**SUBJECT: TDCC Responses to NRC Comments on Final Status Survey Reports for Verification Areas VA-1 through VA-VI**

**NRC Comments and DOW Responses  
DOW Chemical Company's Bay City, MI  
Magnesium-Thorium Slag Storage Area  
Final Status Survey Reports for VA-I through VA-VI**

Figure 3-4  
Sampling Pattern for Composite Preparation Within Decontaminated Grid Block

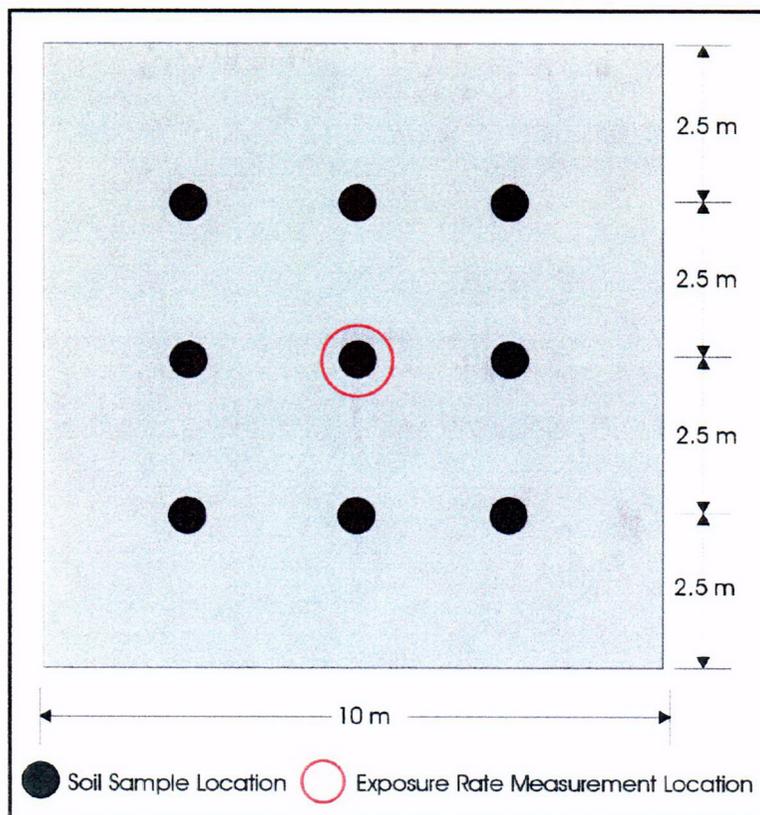
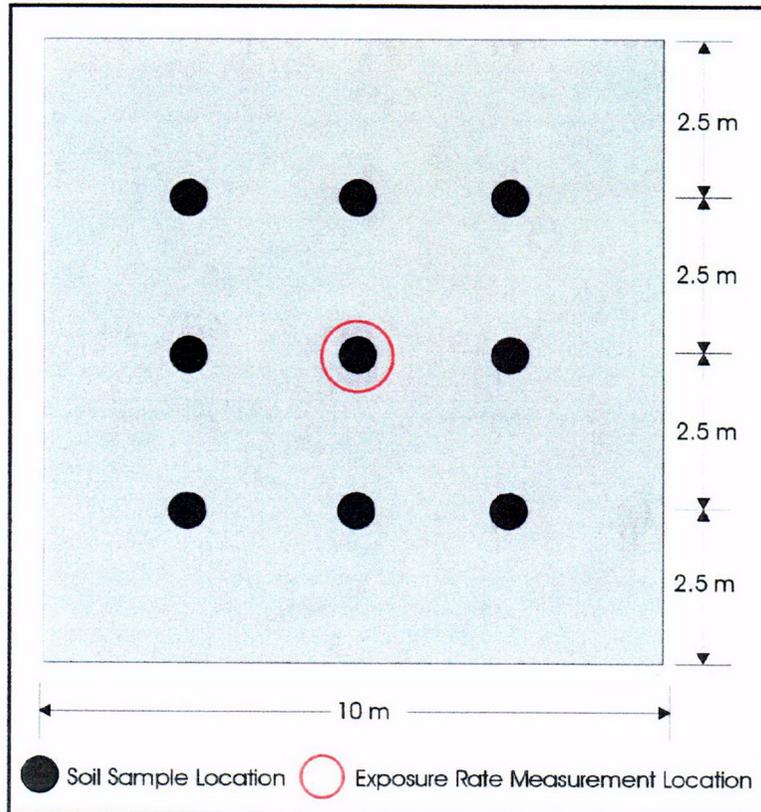
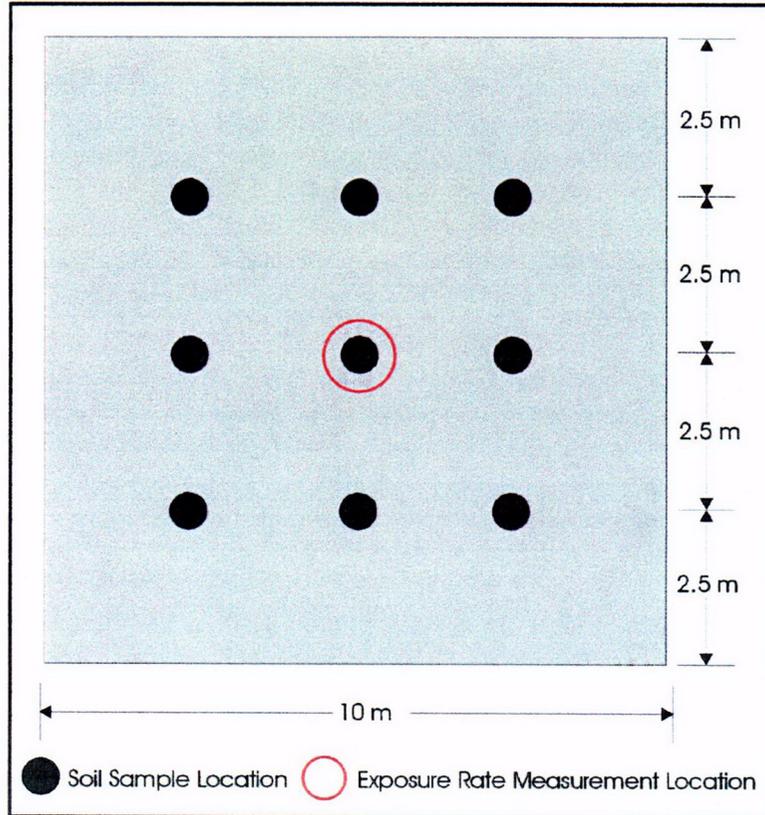
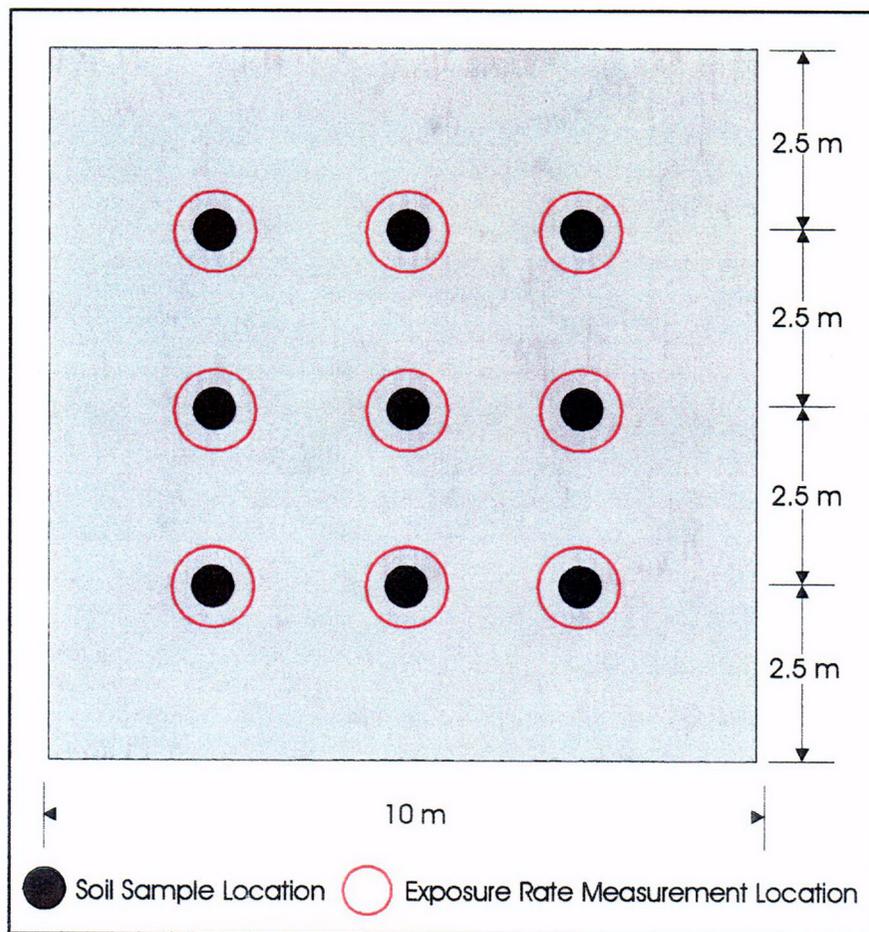
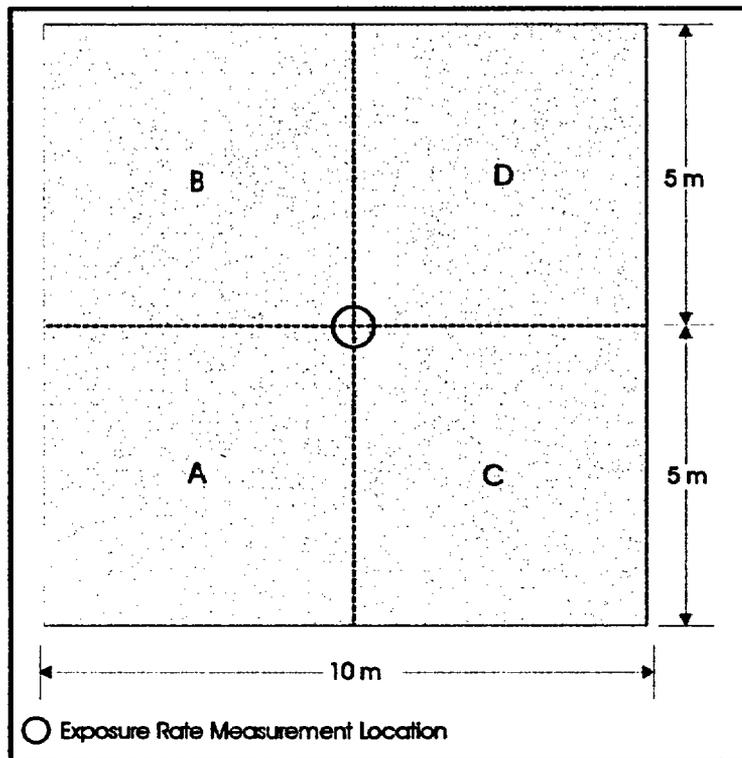
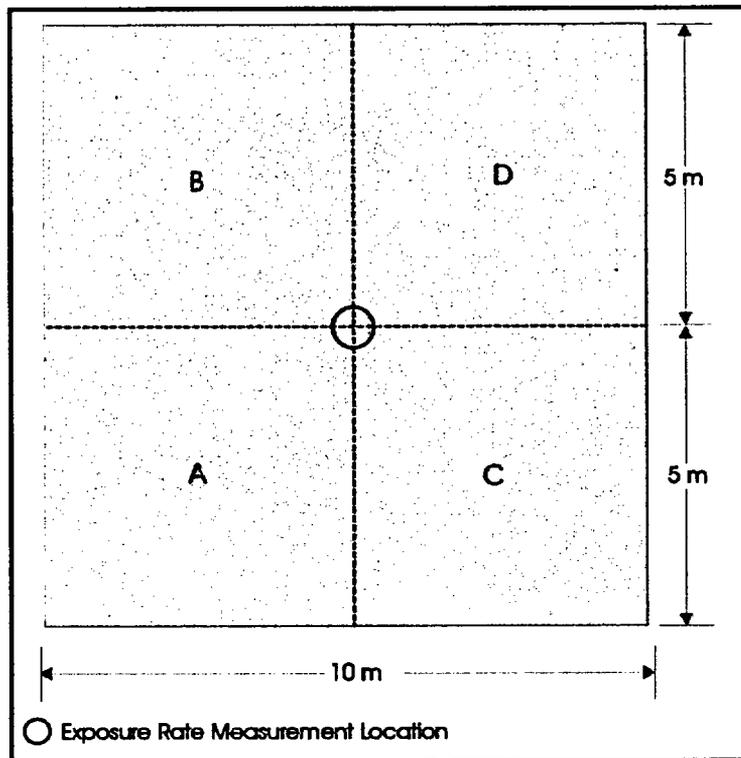
- 1B. The FSSRs need to clearly explain how the remedial action survey was conducted and the data integrated with the final status survey.
- 1C. In addition, to clarify how the final status survey was performed, each report needs to include an example figure of a sub-grid with the sampling locations shown.

- 1B. Section 3.2 of each of the FSSRs has been revised to clarify how remedial action survey data was carried forward and integrated with final status survey data. The final samples collected during the remediation control survey were used as input to the final status survey, providing the sample concentrations did not exceed the soil guideline value. The sampling and analysis scheme used during the remediation control survey was designed to meet the quality and design requirements for FSS as described in the Decommissioning Plan.
- 1C. Figure 3-3, Reference Grid System, and Figure 3-4, Sub-Grid Quadrant Designation, have been included in each FSSR.
